# Access Compliance Report

## Public Rights-of-Way

Intersection ID: 3749	Main Street: FOUNTAINGROVE_DR	Cross Street: PRIORY_CT	Location:	E
ADA ID: 582A487FD536	Ramp Type: Perp	Initial Pass/Fail: Fail	Overall Compliance: No	Severity Score: 21.25
Codes/Mitigation Info/Possible Solution		Field Measurements/Component Compliance

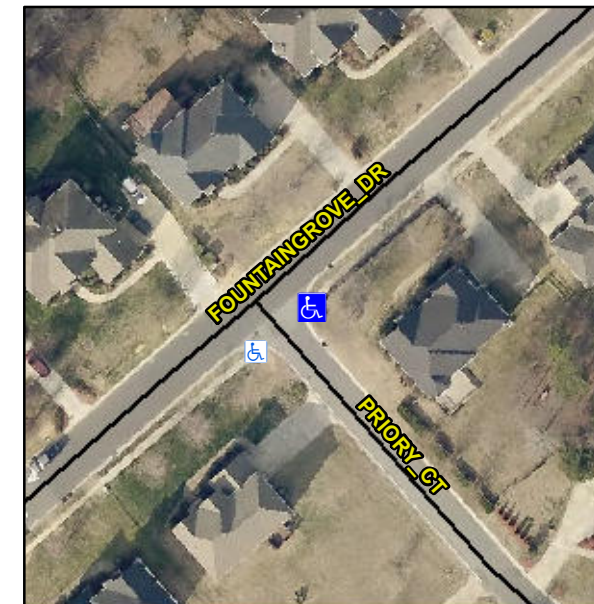
**Not Found, R304.5.1, R304.2.2**

Compliance	Description	Data	Compliance	Description	Data
N/A	Ramp Length (in)	48.0	No	Ramp Slope (%)	9.3
No	Ramp Width (in)	42.0	Yes	Ramp XSlope (%)	1.4
N/A	Flare Type LT	N/A	N/A	Flare Type RT	N/A
N/A	Flare Slope LT (%)	N/A	N/A	Flare Slope RT (%)	N/A
N/A	Flare Traversable LT?	N/A	N/A	Flare Traversable RT?	N/A
N/A	Landing Length (in)	N/A	N/A	DWS Provided?	N/A
N/A	Landing Width (in)	N/A	N/A	DWS Contrast?	N/A
N/A	Landing Slope (%)	N/A	N/A	DWS Length (in)	N/A
N/A	Landing X Slope (%)	N/A	N/A	DWS Full Width?	N/A
N/A	Landing Curb? (Y/N)	N/A	N/A	DWS Offset (in)	N/A
N/A	Shared Landing?	N/A			
N/A	Gutter Ponding?	N/A	N/A	Gutter Slope (%)	N/A
N/A	Gutter Lip Ht (in)	N/A	N/A	Gutter X Slope (%)	N/A
N/A	Painted X Walk1?	No	N/A	Painted X Walk2?	N/A
	X Walk 1 Direction	To SW		X Walk 2 Direction	N/A
N/A	X Walk 1 Width (in)	N/A	N/A	X Walk 2 Width (in)	N/A
	X Walk 1 Slope (%)	1.6		X Walk 2 Slope (%)	N/A
	X Walk 1 X Slope (%)	2.0		X Walk 2 X Slope (%)	N/A

**Remove & Replace Entire Ramp.**
